REBUTTAL REPORT: PART 1

**REVIEW OF EVIDENCE REPORTS SUBMITTED BY SOUTHERN NEVADA WATER AUTHORITY IN SUPPORT
OF WATER RIGHTS APPLICATIONS FOR SPRING, CAVE, DRY LAKE, AND DELAMER VALLEYS**

Presented to the Office of the Nevada State Engineer

August 25, 2011

Figure 19: Snapshot of Figure 4-1 from the SNWA Effects report.

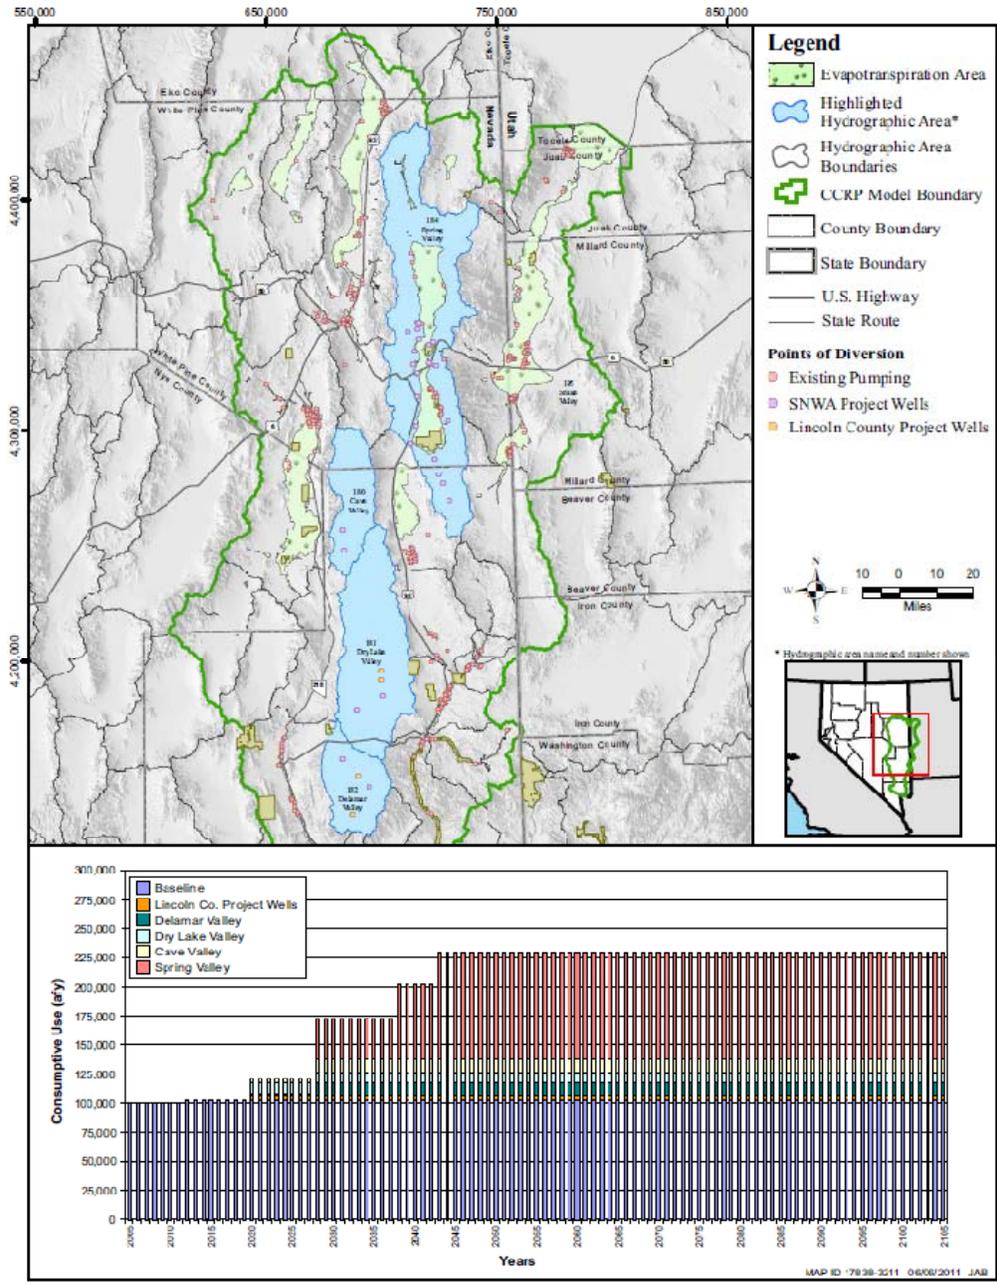
SNWA considered only one potential pumping scenario, as shown in Figure 19. The details of this are that starting in 2019 and 2028, the simulation pumps 14,077 and 34,751 af/y from the Cave, Dry Lake and Delamar Valleys; and in 2028, 2038, and 2042, the simulation pumps 35,000, 64,544, and 91,222 af/y, respectively, from Spring Valley (Table 4-1). Presumably the amount by valley is distributed proportionally among the wells (the report does not state as much). SNWA has not provided the NSE with a full-range of pumping rates or schedules for comparison, as does Myers (2011d).

The report describes the simulation as unrealistic and conservative (p. 4-3). It is anything but – SNWA may pump the full amount from the day the NSE grants the water rights and SNWA constructs the facilities. The ramping schedule analyzed (Figure 19) is not described or justified in the Effects report. There is no justification for considering anything less than pumping the full granted amount from the beginning.
